RULE NO. R161-26.24

NOTICE OF PROPOSED RULE **POSTING DATE: August 24, 2026**

R161-26.24: Proposed revision to Standard 511

Rule 2 – Revisions to Standard 511

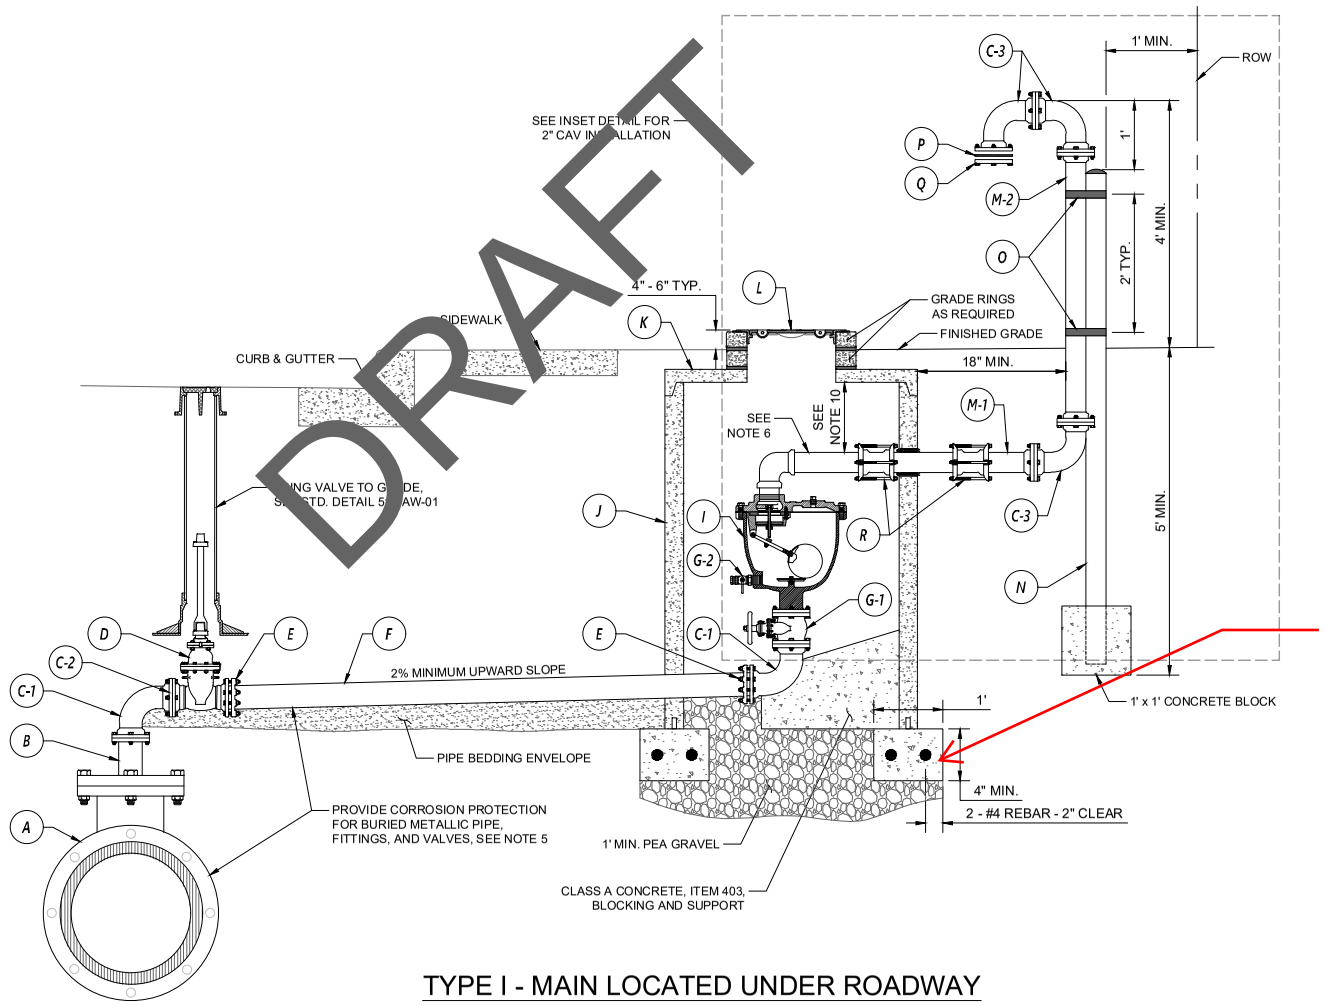
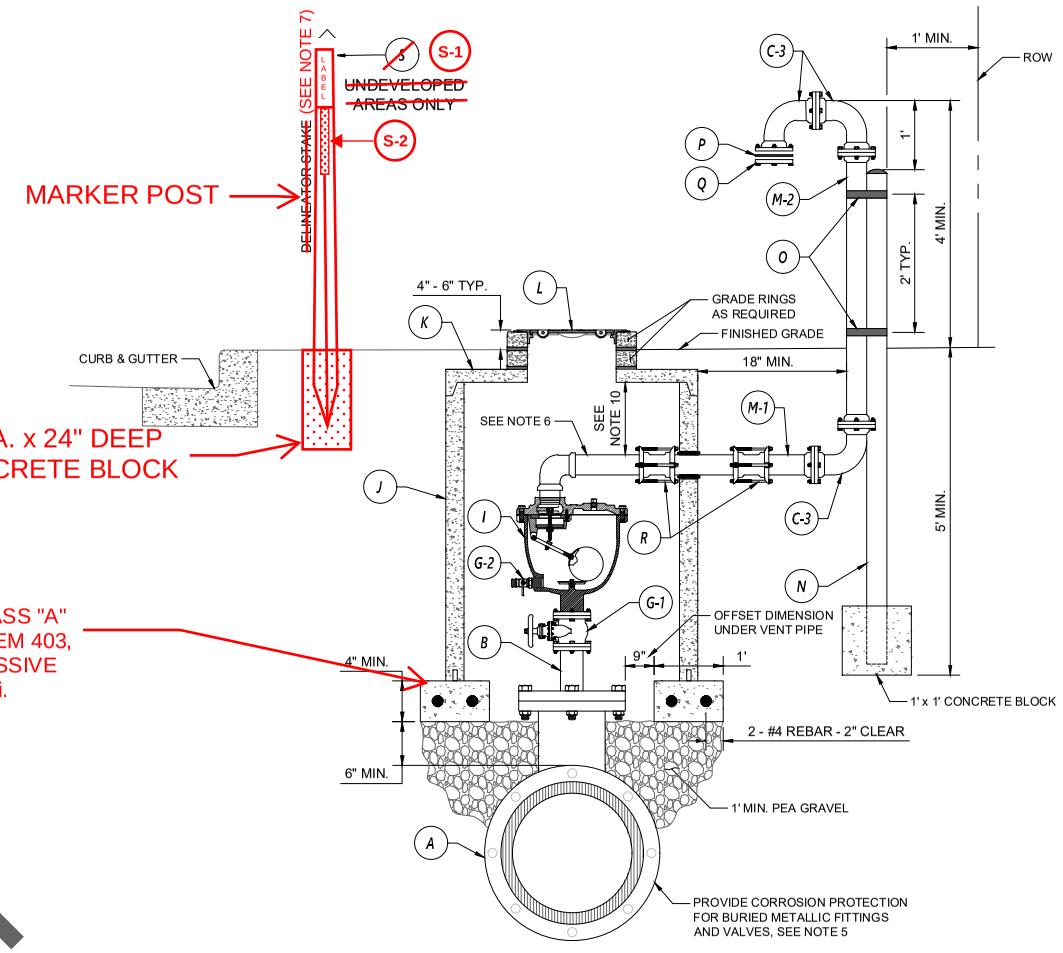
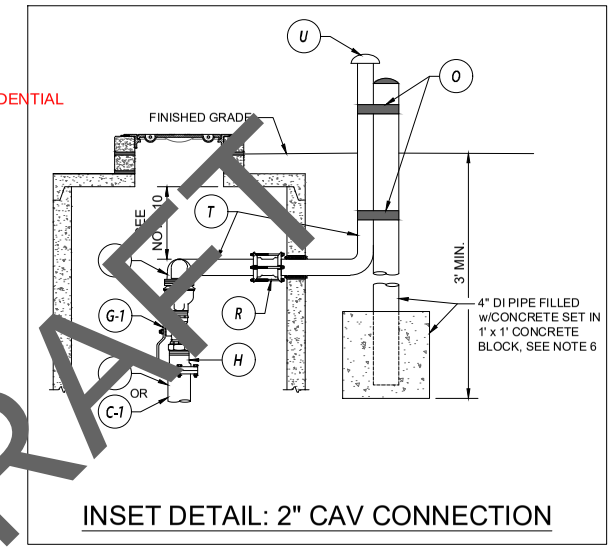
1. **Standard 511-AW-04A** – Update detail to include latest marker post requirements and clarification of base ring.

7. IN NON-RESIDENTIAL AND UNMANICURED AREAS INSTALL ONE MARKER POST IN CONCRETE PAD FACING THE VEHICULAR ACCESS SIDE OR AS DIRECTED BY AW OR INSPECTOR. MARKER POST SHALL BE BLUE FOR POTABLE OR PURPLE FOR RECLAIMED AND EXTEND AT LEAST 48" ABOVE FINISHED GRADE. 2" WIDE AND 12" LONG, WHITE, DOT-C2 REFLECTIVE TAPE TO BE APPLIED BY CONTRACTOR TO FRONT OF MARKER POST AS SHOWN.

7. IN ~~UN~~DEVELOPED AREAS INSTALL ONE DELINEATOR STAKE WITHIN 3' OF THE VAULT ON THE VEHICULAR ~~ACCESS SIDE OR~~ AS DIRECTED BY AW. DELINEATOR SHALL BE BLUE FOR POTABLE OR PURPLE FOR RECLAIMED ~~AND EXTEND~~ AT LEAST 60" ABOVE FINISHED GRADE. DELINEATOR SHALL HAVE 2" WIDE, WHITE IN COLOR, TYPE I REFLECTIVE TAPE MOUNTED DIAGONALLY AT 12" SPACING ON BOTH SIDES.

S-1. MARKER POST, WW-595, SEE NOTE 7

S-2. DOT-C2 REFLECTIVE TAPE, WHITE, 2" WIDE AND 12" LONG, SEE NOTE 7.

CITY OF AUSTIN AUSTIN WATER	COMBINATION AIR VALVE (CAV) ASSEMBLIES FOR FORCE MAINS (2", 4" & 6" ONLY)	
DRAFT 07/16/2026 ADOPTED	THE ENGINEER/ARCHITECT ASSUMES RESPONSIBILITY FOR APPROPRIATE USE OF THIS STANDARD. MODIFICATIONS TO THIS STANDARD ARE PROHIBITED.	STANDARD NO. 511-AW-04B 1 OF 1

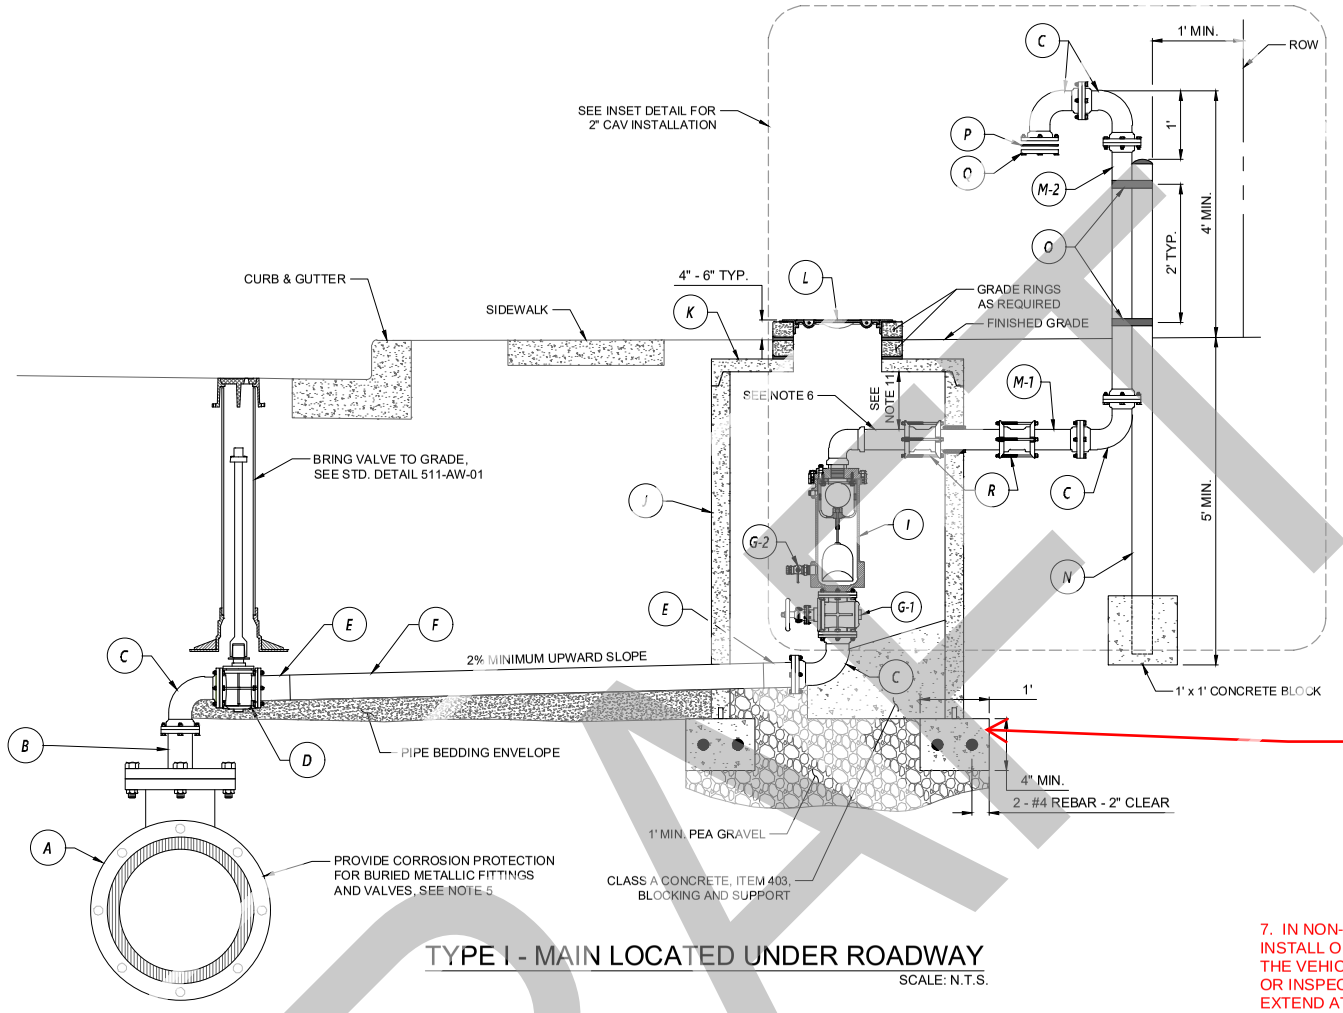
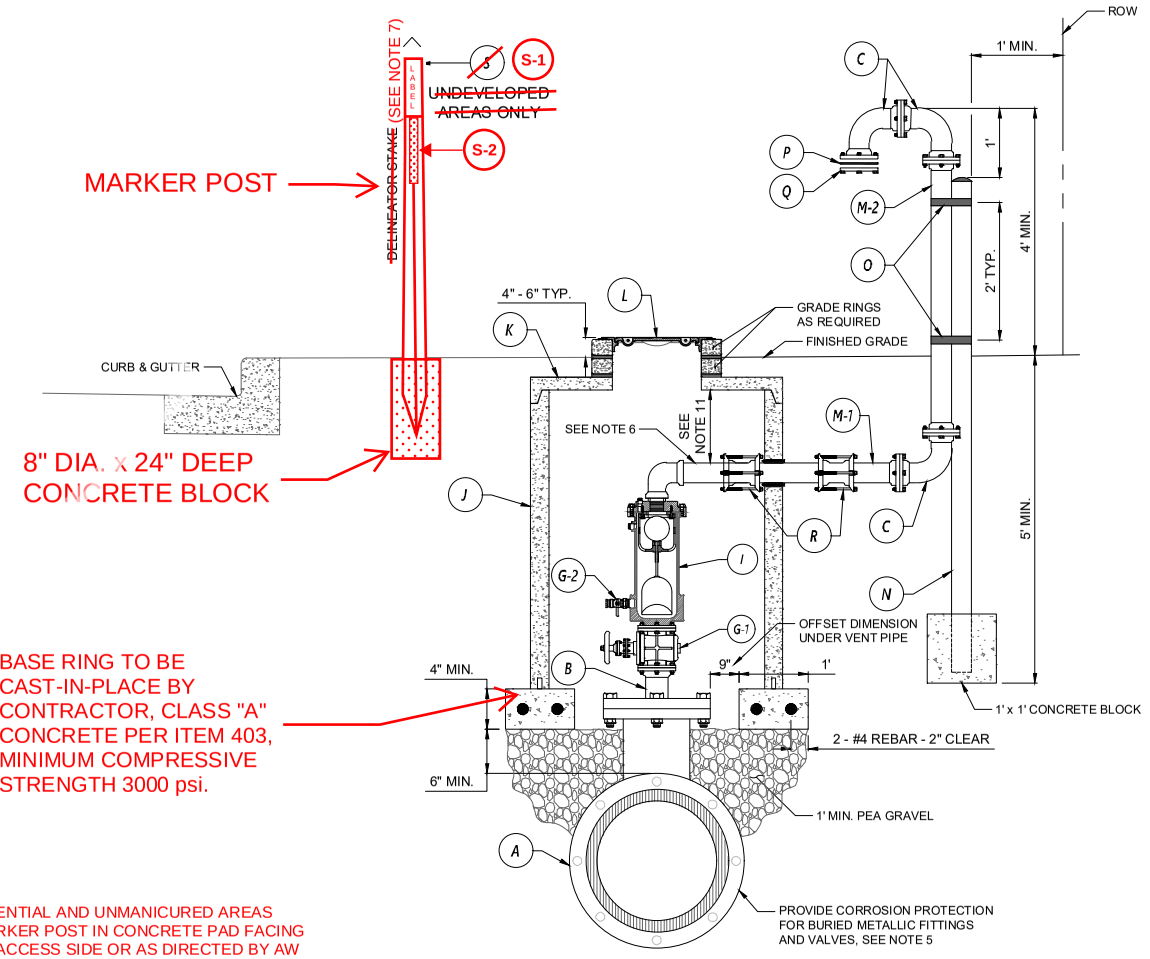
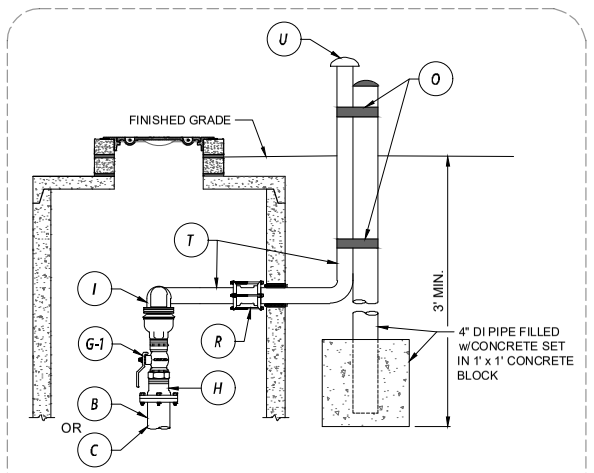
2. **Standard 511-AW-04B** – Update detail to include latest marker post requirements and clarification of base ring.

7. IN NON-RESIDENTIAL AND UNMANICURED AREAS INSTALL ONE MARKER POST IN CONCRETE PAD FACING THE VEHICULAR ACCESS SIDE OR AS DIRECTED BY AW OR INSPECTOR. MARKER POST SHALL BE GREEN AND EXTEND AT LEAST 48" ABOVE FINISHED GRADE. 2" WIDE AND 12" LONG, WHITE, DOT-C2 REFLECTIVE TAPE TO BE APPLIED BY CONTRACTOR TO FRONT OF MARKER POST AS SHOWN.

7. ~~IN UNDEVELOPED AREAS~~ INSTALL ONE DELINEATOR STAKE WITHIN 3' OF THE VAULT ON THE VEHICULAR ACCESS SIDE OR AS DIRECTED BY AW. DELINEATOR SHALL BE GREEN AND EXTEND ~~AT LEAST 66" ABOVE FINISHED GRADE~~. DELINEATOR SHALL HAVE 2" WIDE, WHITE IN COLOR, TYPE I REFLECTIVE TAPE MOUNTED DIAGONALLY AT 12" SPACING ON BOTH SIDES.

S-1. MARKER POST, WW-595, SEE NOTE 7

S-2. DOT-C2 REFLECTIVE TAPE, WHITE, 2" WIDE AND 12" LONG, SEE NOTE 7.
